**DOCUMENT 00 90 00
ADDENDUM**

ADDENDUM NO. [1] Date: August 14, 2019

**RE: LANESBORO PUBLIC SCHOOLS
 ADDITION AND REMODEL
 100 KIRKWOOD ST EAST
 LANESBORO, MN 55949
 HSR 18063**

**FROM: HSR Associates, Inc
 100 Milwaukee Street
 La Crosse, WI 54603
 (608) 784-1830**

P400

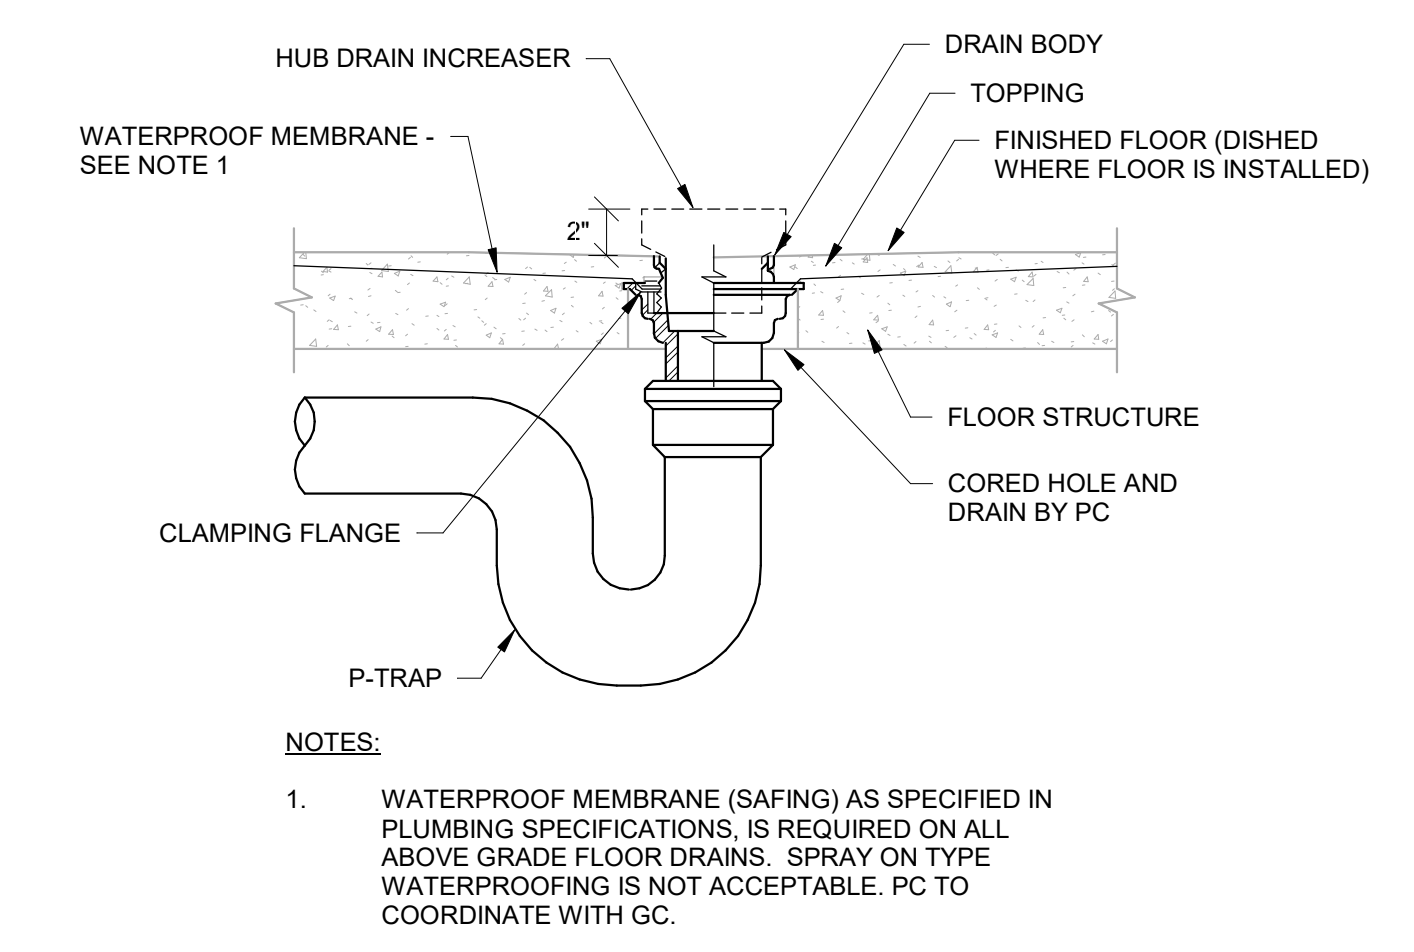
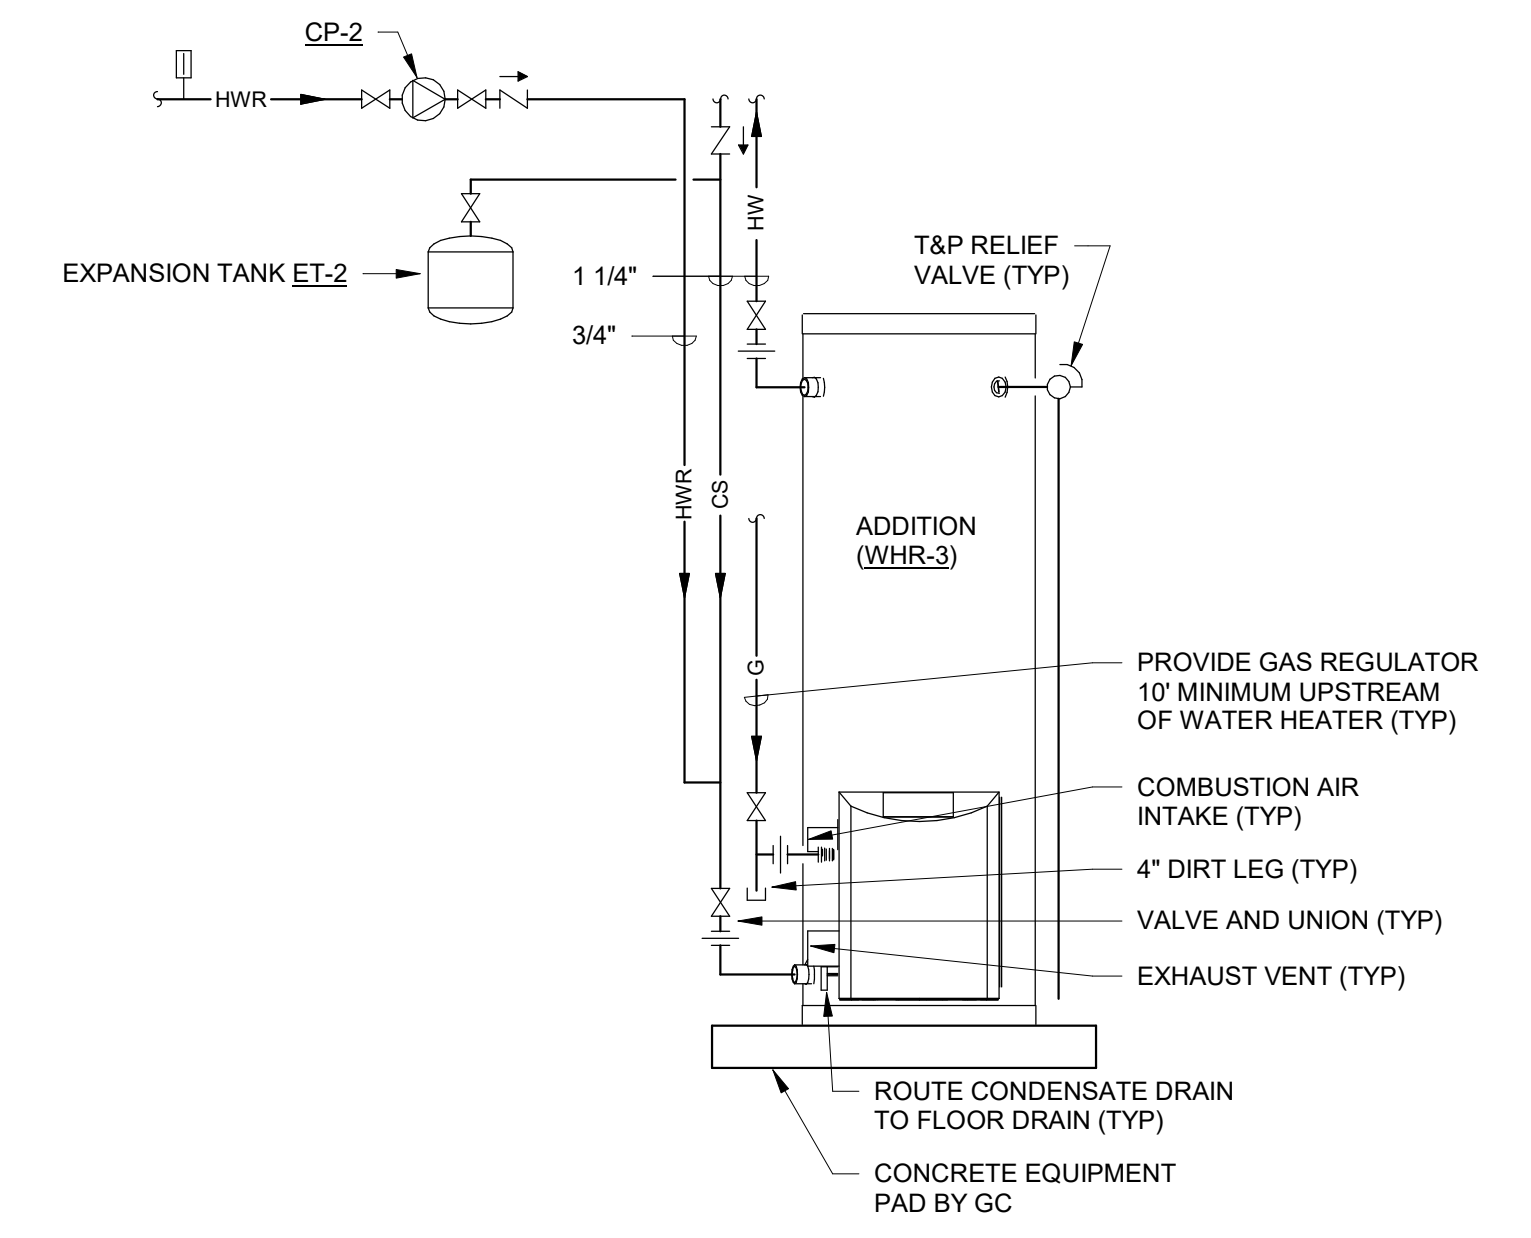
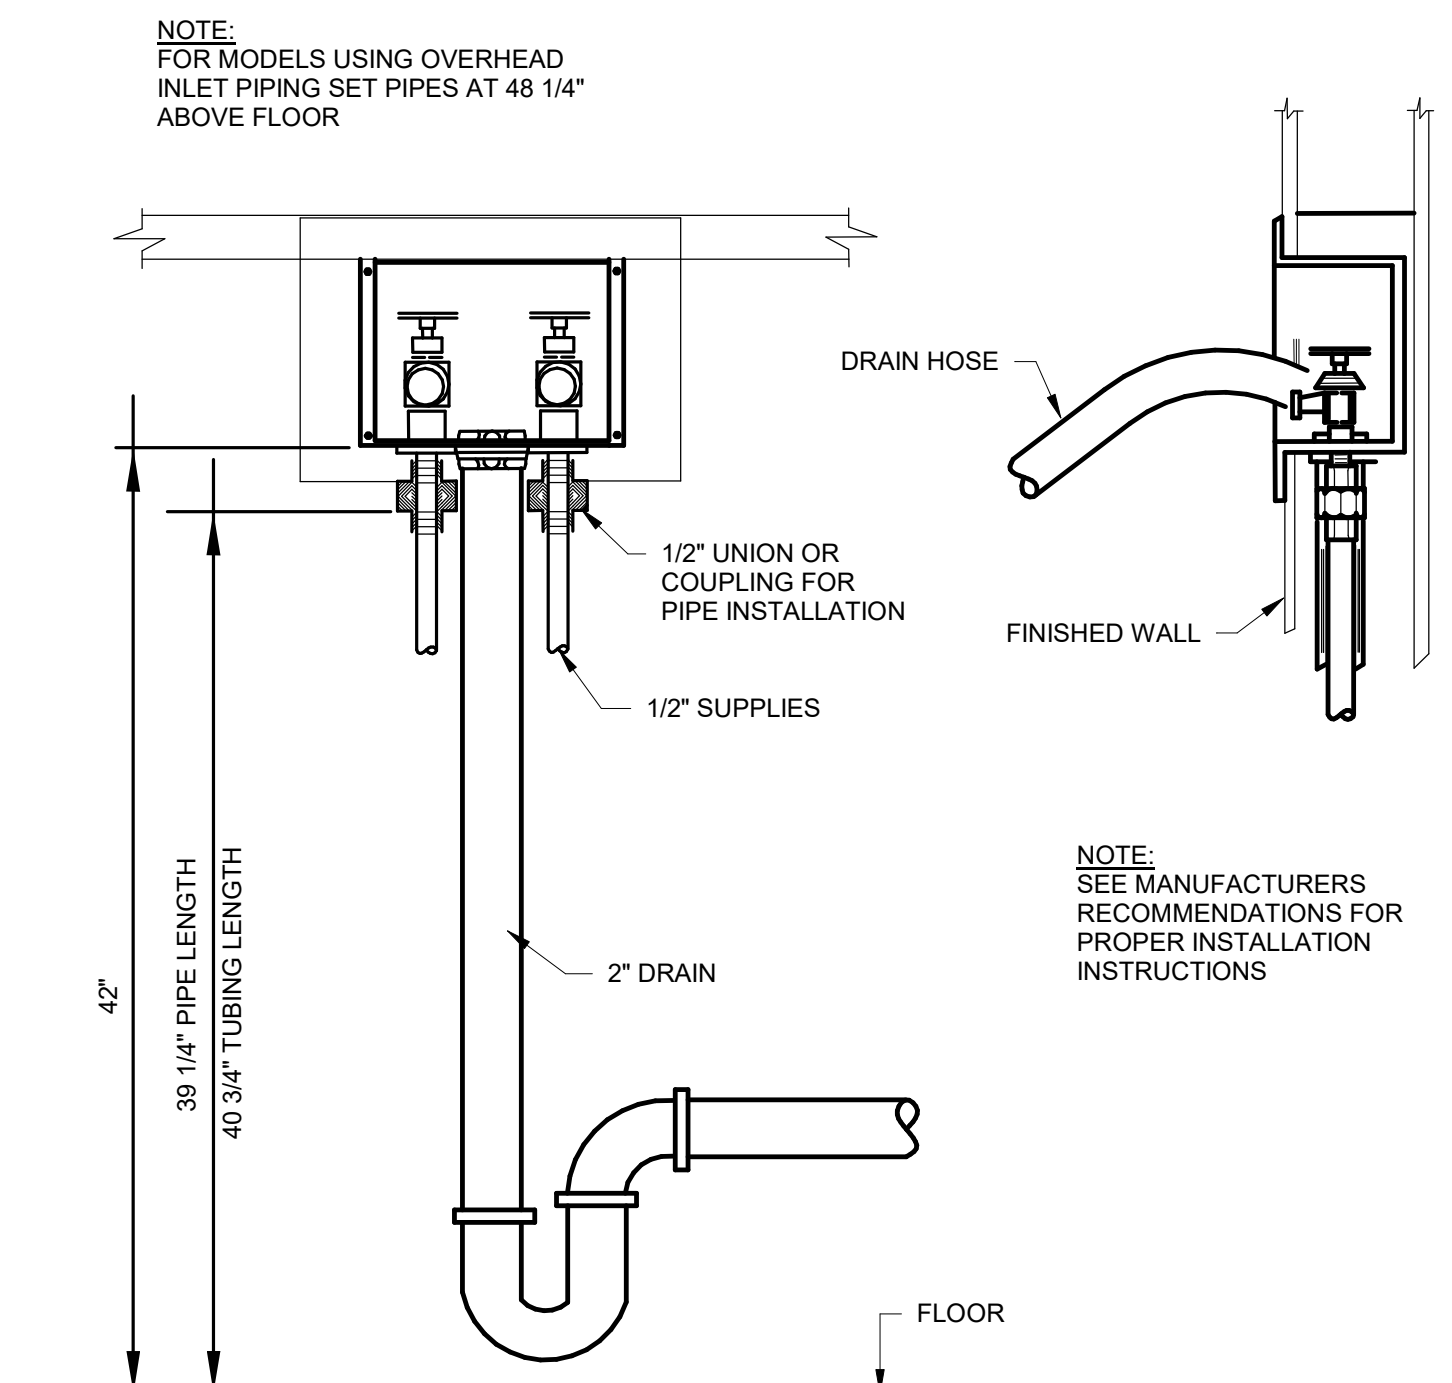
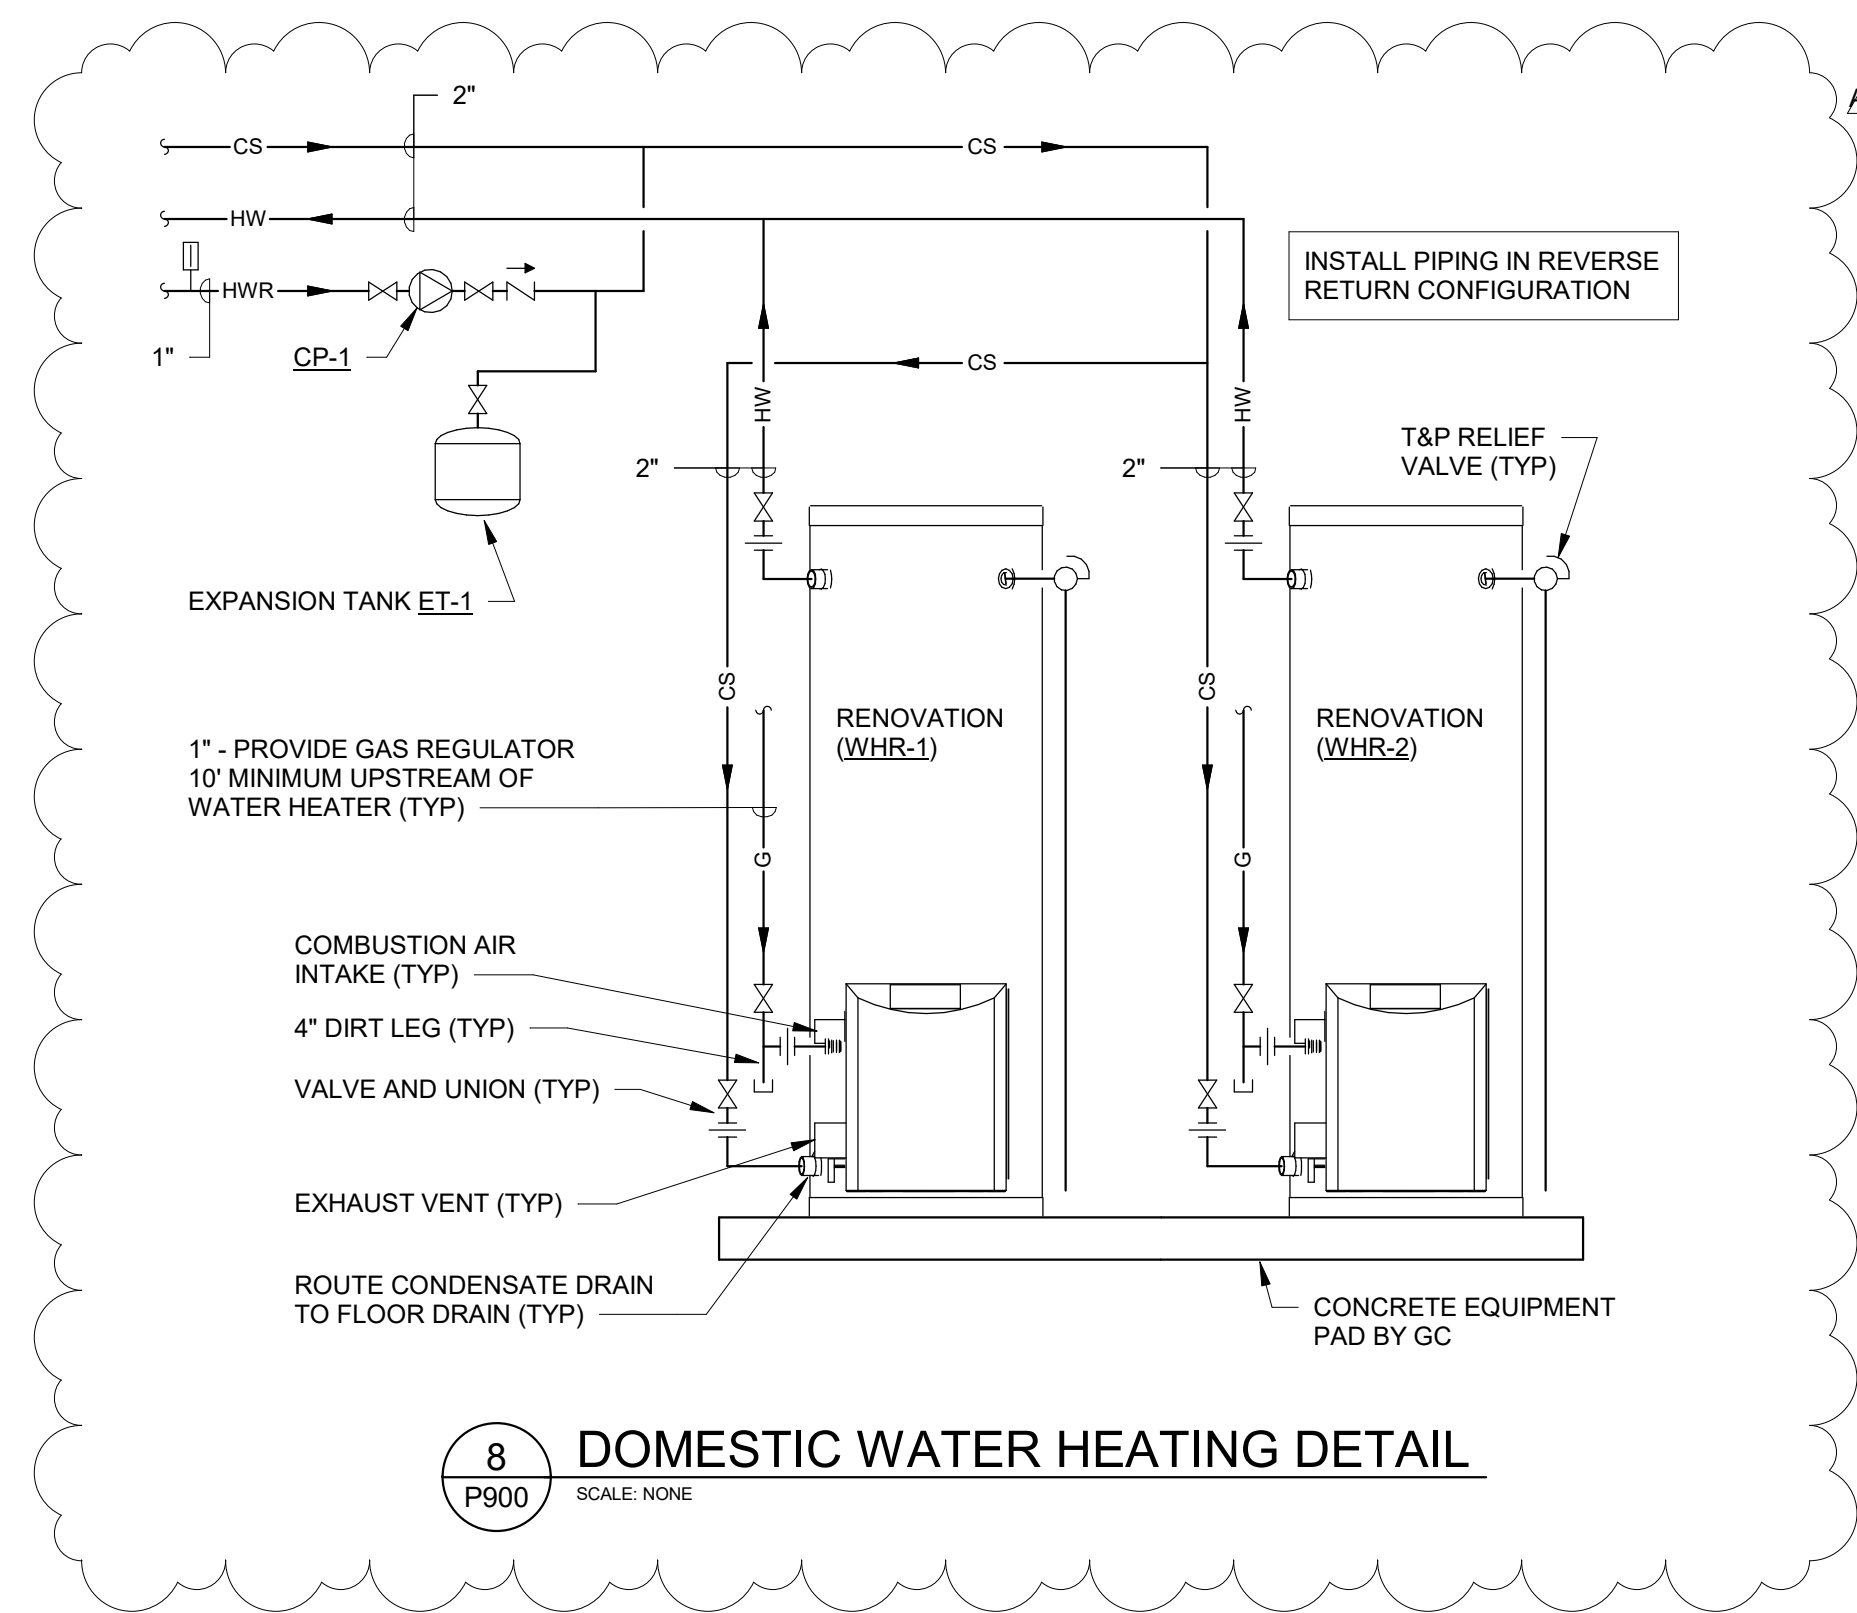
- b. Revise per floor plan changes, as shown.
41. Sheet P400 ENLARGED FLOOR PLANS – PLUMBING 30 x 42 attached hereto
 - a. Revisions clouded on Drawing.

- b. Add pipe sizes, as shown.
 - c. Add caps on water at existing main, as shown.
 - d. Add water up to emergency eyewash, as shown.
42. Sheet P900 DETAILS – PLUMBING 30 x 42 attached hereto
